Transport
for NSW

Macquarie Park Precinct and Bus Interchange upgrade

Submissions Report
December 2022

Figure 3-1: Location of existing and proposed Macquarie Centre exits

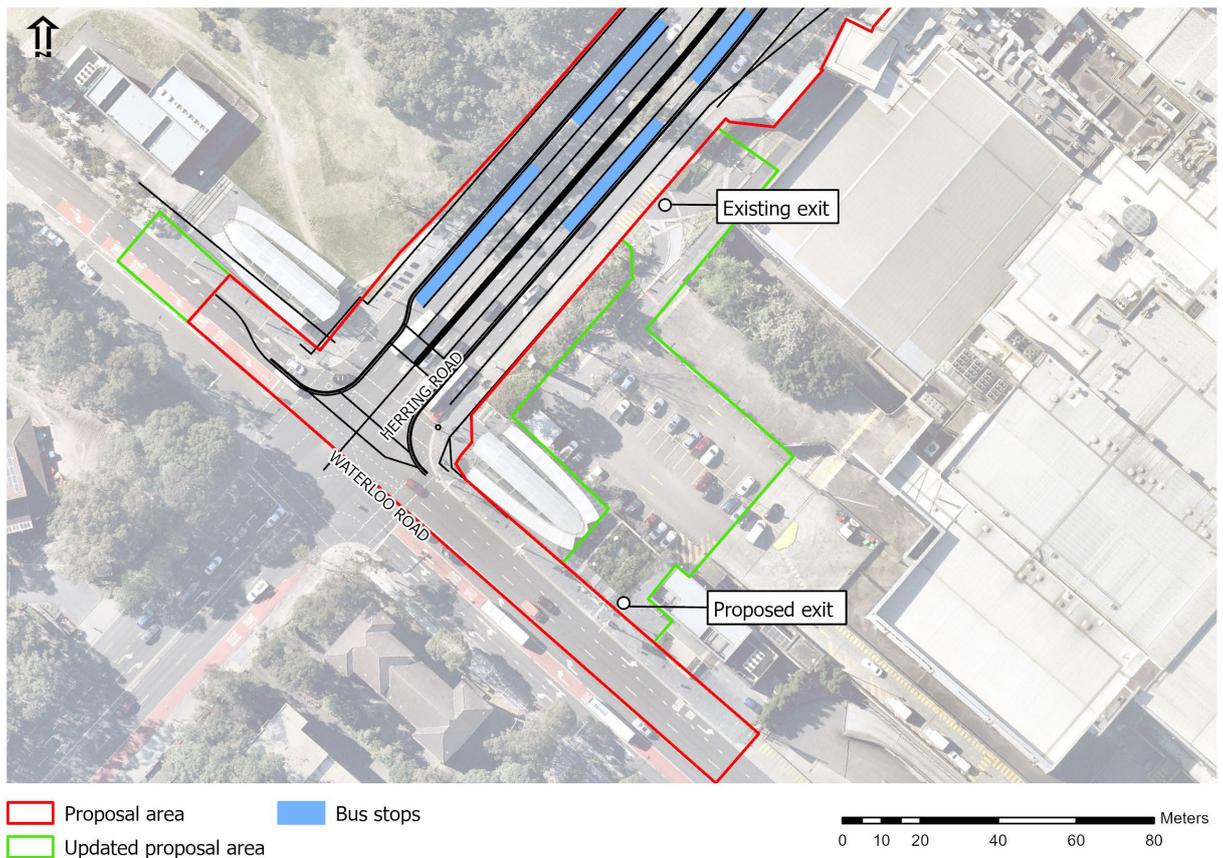
Transport is proposing to relocate the existing Macquarie Centre exit, located about 60 metres north of the Herring Road / Waterloo Road intersection, to a new location on Waterloo Road. The location of the existing exit and proposed exit is shown in Figure 3-1.

While the future redevelopment of Macquarie Centre would remove the need for the existing exit, the timing of that redevelopment means a temporary solution is required to address the following issues at Herring Road:

- conflict point between customers accessing the Metro, Macquarie Centre and Macquarie University, bus stands and exiting vehicles
- drivers exiting onto Herring Road from Macquarie Centre have limited views of approaching traffic due to the driveway gradient and vegetation
- proposed plaza space has increased adjacent to Herring Road southbound which in turn would increase conflict zone with pedestrians
- potential interference with bus interchange operations
- potential for driver confusion regarding traffic arrangements on Herring Road and need for a change to traffic lights to accommodate general traffic on this section of Herring Road.

Relocation of the Macquarie Centre car park exit (as shown in Figure 3.1) would not adversely affect traffic flow on Waterloo Road and is located a safe distance from the Herring Road / Waterloo Road intersection. The relocated exit is less likely to interfere with pedestrian movements (compared with the existing exit) and would not interfere with the operation of the bus interchange. The design of the exit would occur in consultation with the City of Ryde and AMP Capital.

Figure 3-2: Proposed exit to Waterloo Road

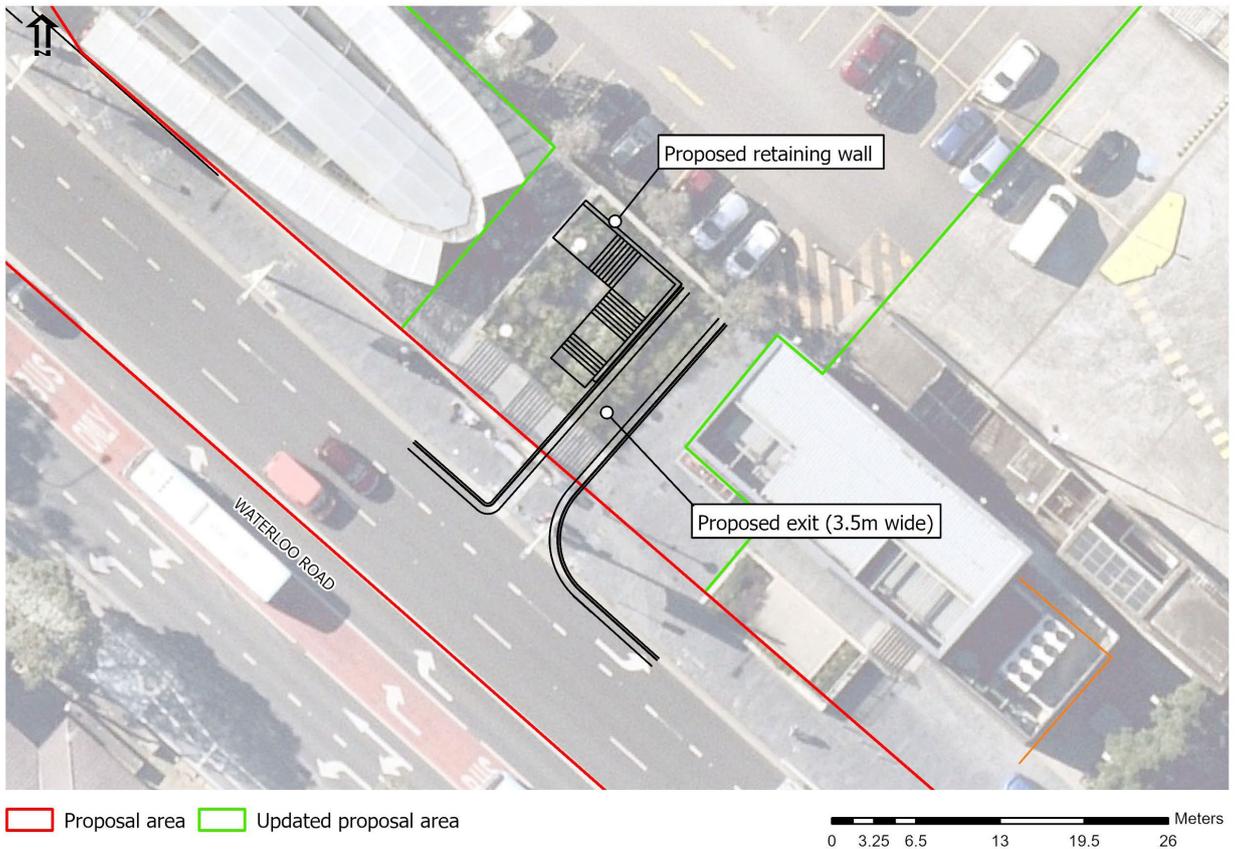
The proposed change involves the following (refer also to Figure 3-2):

- reconfiguration of the staircase and retaining walls to allow for the exit
- relocation of bus stop (2113318) a short distance to the west on Waterloo Road
- removal of landscape vegetation and up to four trees within the existing car park
- relocation or removal of street lighting (one pole), lighting within the landscaped area (two poles) and street furniture (including bins)
- protection and/or adjustment of utilities
- civil works associated with the closure of the existing exit on Herring Road.

While the existing car park is shown within the updated proposal area, this car park would remain operational during works with any temporary impacts on vehicle movements or parking capacity to be addressed in consultation with AMP Capital (Macquarie Centre).

Figure 3-3: Kiss and ride locations

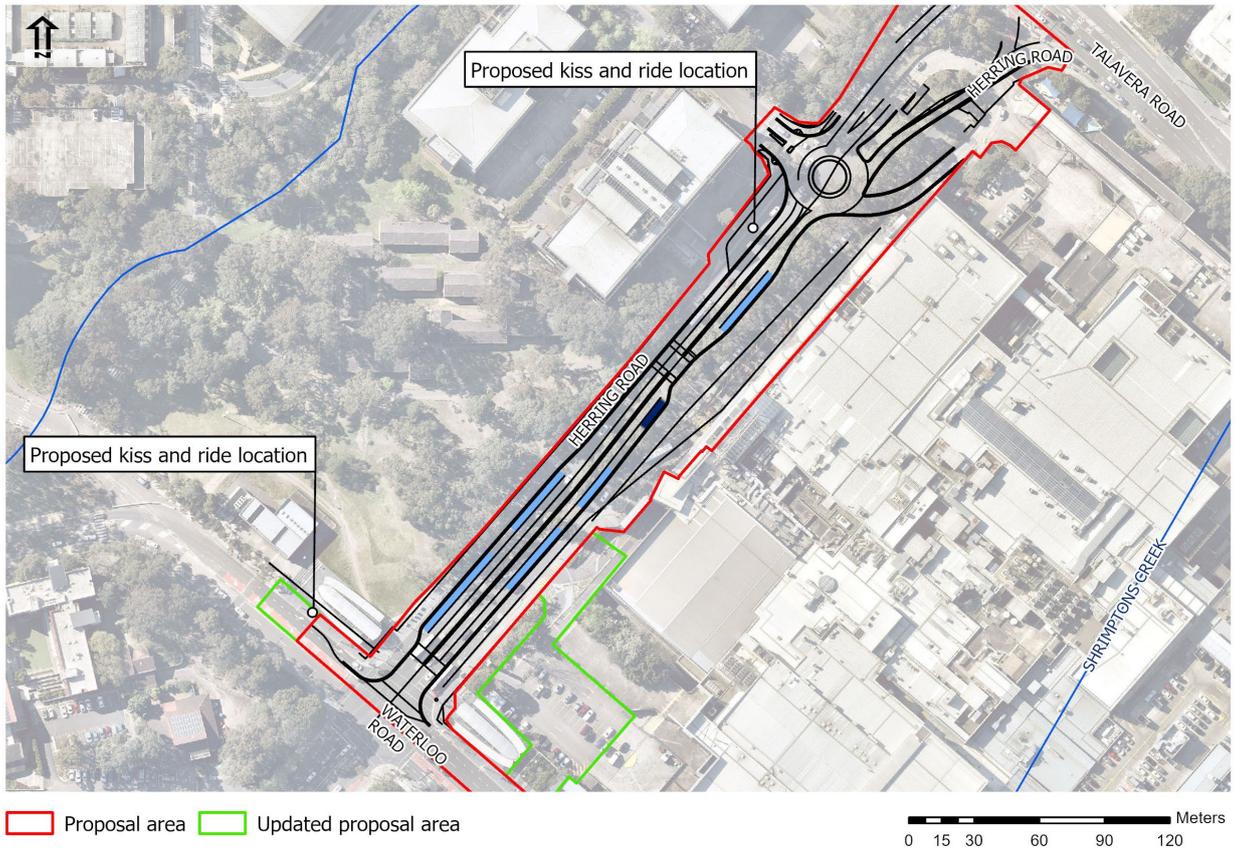
Transport is proposing to relocate the kiss and ride zone (one space) on Herring Road south of the mid-block pedestrian crossing to Herring Road near Innovation Road and /or University Avenue. Works would be limited to the provision of signage at these locations.

The provision of the kiss and ride at the two proposed locations would result in negligible visual change, with the small-scale signage being consistent with the existing and proposed character of LCZ7. The proposed kiss and ride would not alter the impact ratings for LCZ7 (high).
